Carolina Power & Light Company

SERIAL: NLS-84-051

BRUNSWICK STEAM ELECTRIC PLANT, UNIT NOS. 1 AND 2
DOCKET NOS. 50-325 & 50-324/LICENSE NOS. DPR-71 & DPR-62
ELECTRICAL DISTRIBUTION SYSTEM VOLTAGES

Answers to Request for Additional
Information Dated September 1, 1983
Question 7, 8, and 9

SKETCH 1

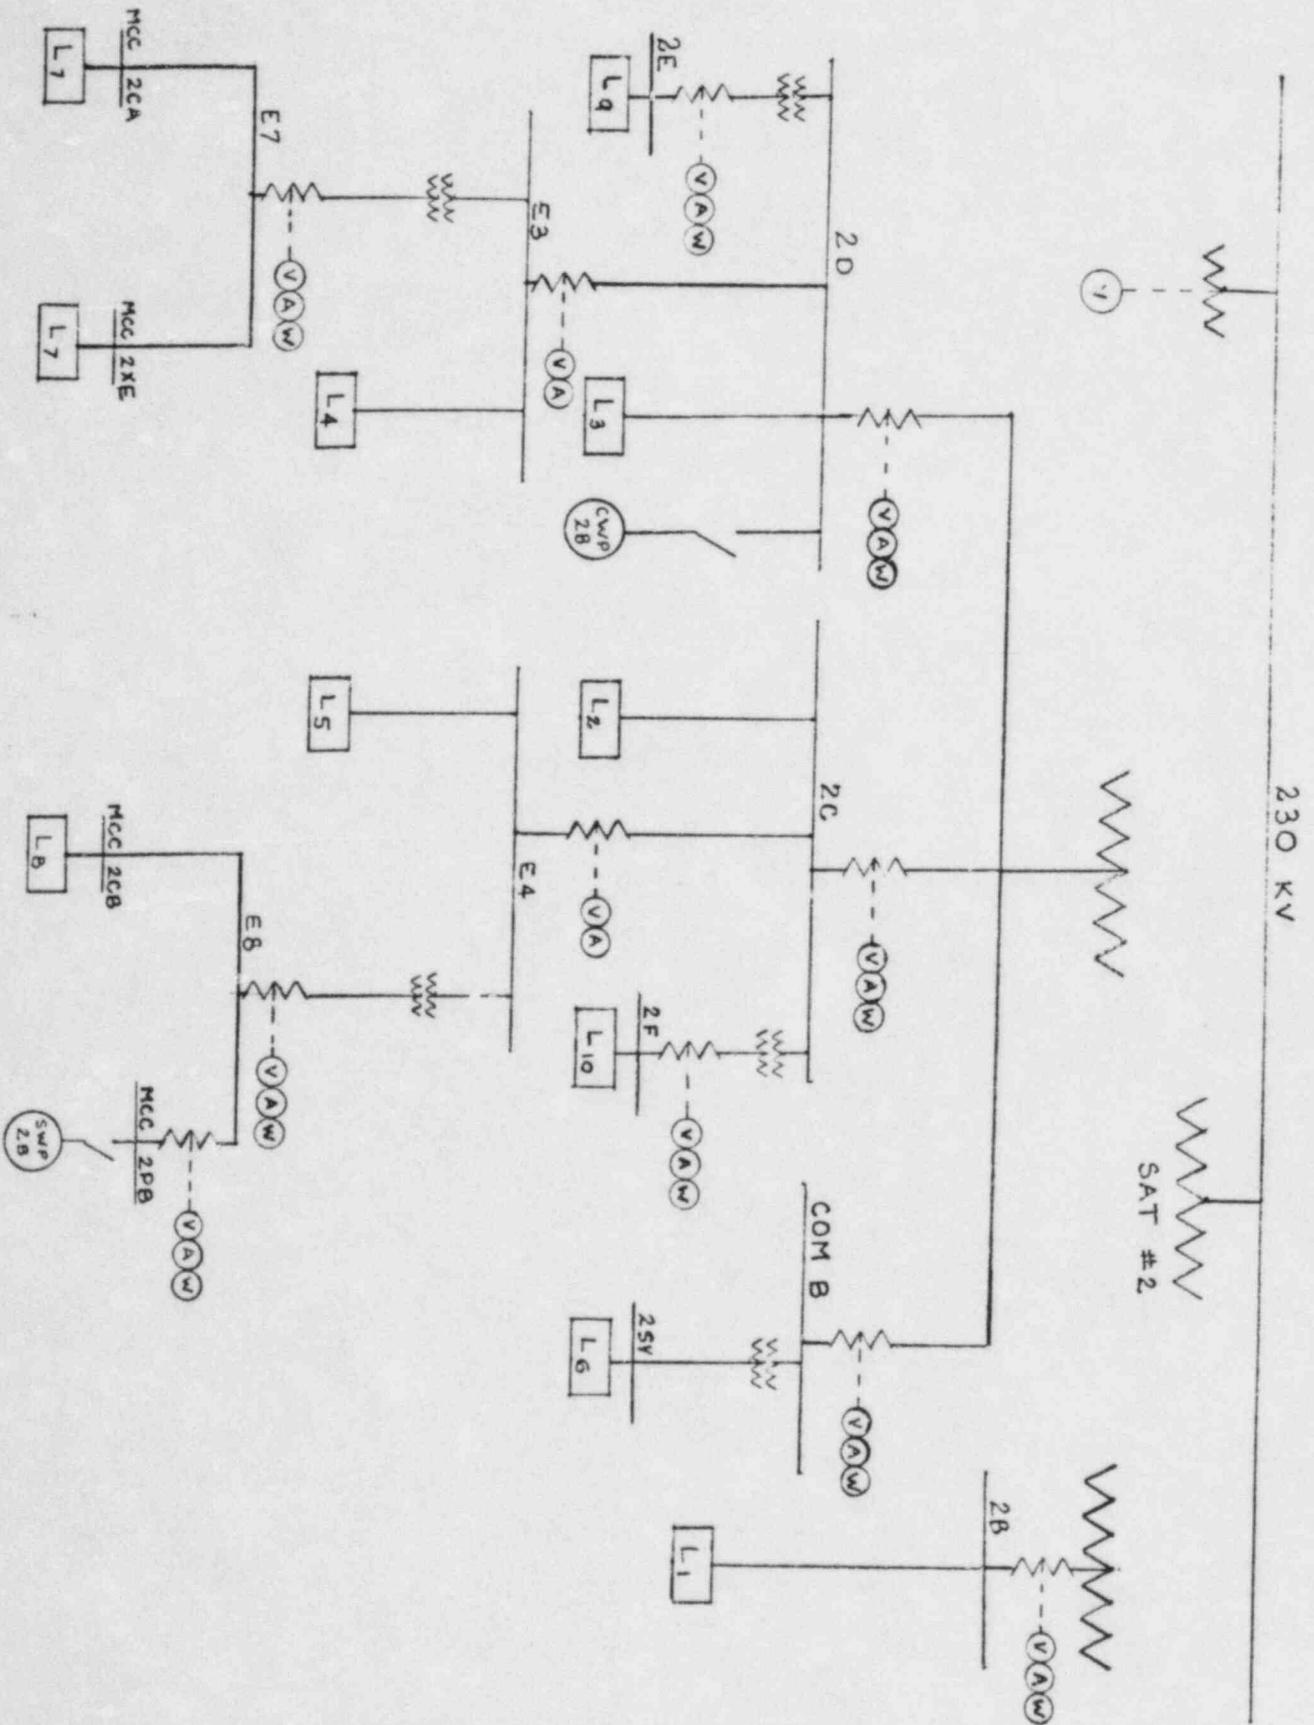
Demonstrate that the test measurements and test analysis were for identical station electrical loading.

Response

The BOP and emergency bus loads were fed from the startup transformer No. 2. At the time of the test, the power generator was 40% of the rated capacity of each unit and the following major loads were running:

The above station loads were measured at the same time (15:48 p.m., December 12, 1980) at various locations as shown on Sketch 1.

For test analysis, megawatts were taken directly from site test data and megavars were computed (see Appendix A of the study report) from megawatt, voltage, and current data with the exception of motor starting loads noted in Response 8.
